Planning Board Village of Tarrytown Regular Meeting April 30, 2018 7:00 pm

Statement II of Geraldine F Baldwin Re: Errors in Site Plan of March 14, 2018 Re: 67 Miller Avenue

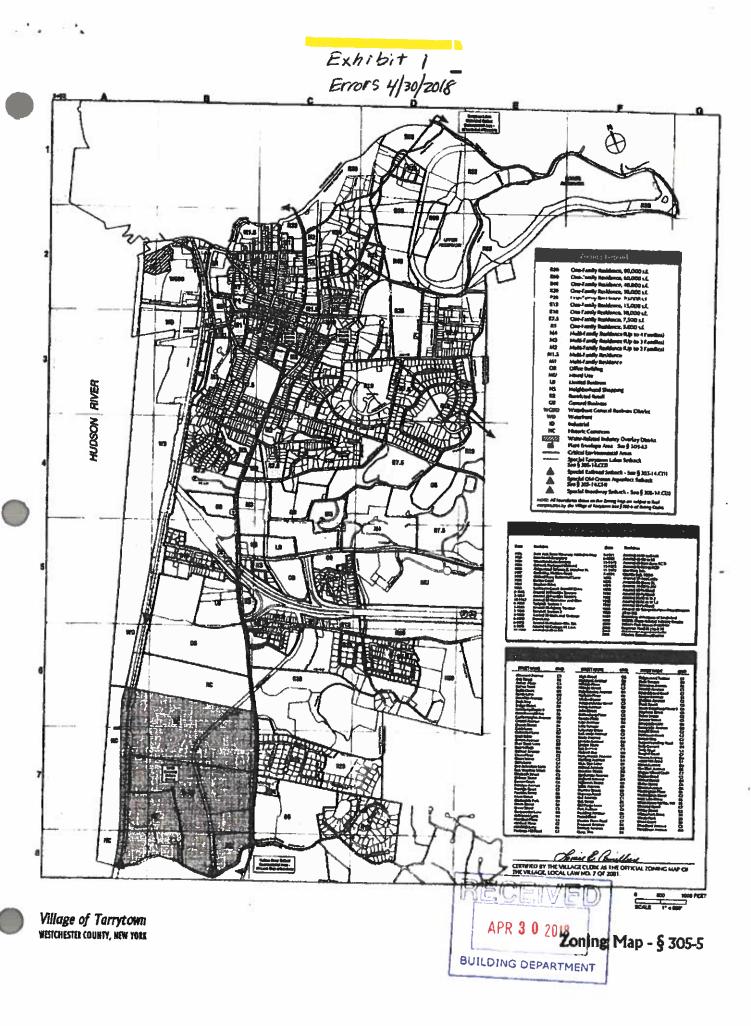
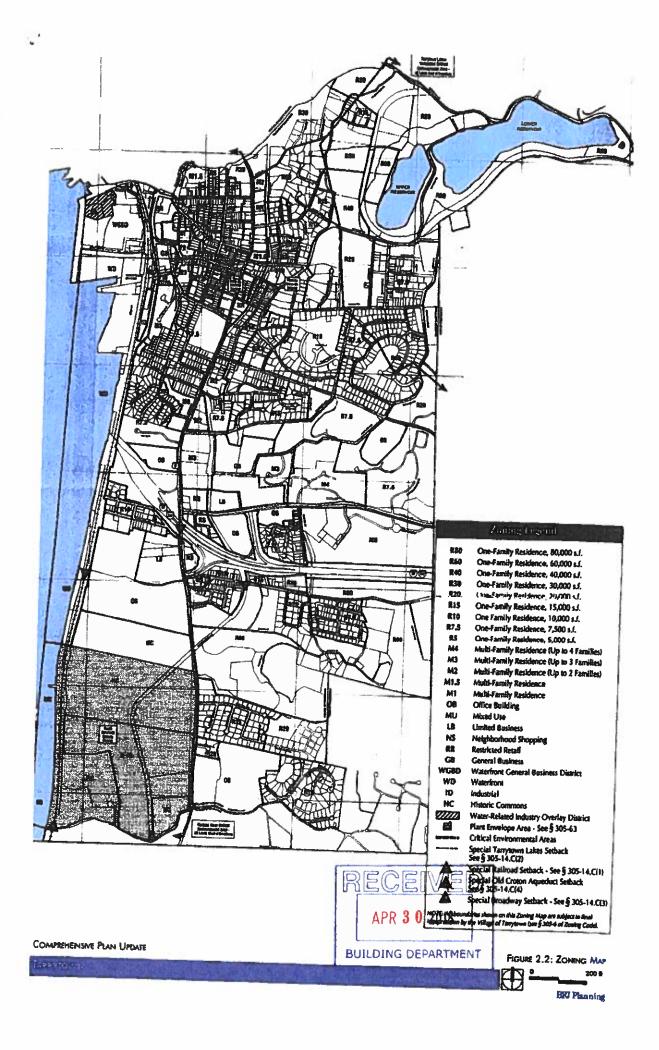
The following corrections need to be made to the Site Plans dated March 14, 2018, submitted on behalf of Applicant of 67 Miller Avenue on April 16, 2018:

- 67 Miller Avenue is NOT in the R10 Zoning District. This property and the whole of the Benedict Park subdivision are in the R 7.5 Zoning District. [See the Zoning District map, attached hereto as Exhibit 1].

- In fact, Applicant admitted that the property is the R7.5 Zoning District when he submitted a site plan to the Architectural Review Board in 2011. [See Plan submitted by Applicant on March 28, 2011 in the records of the Building Dept.].
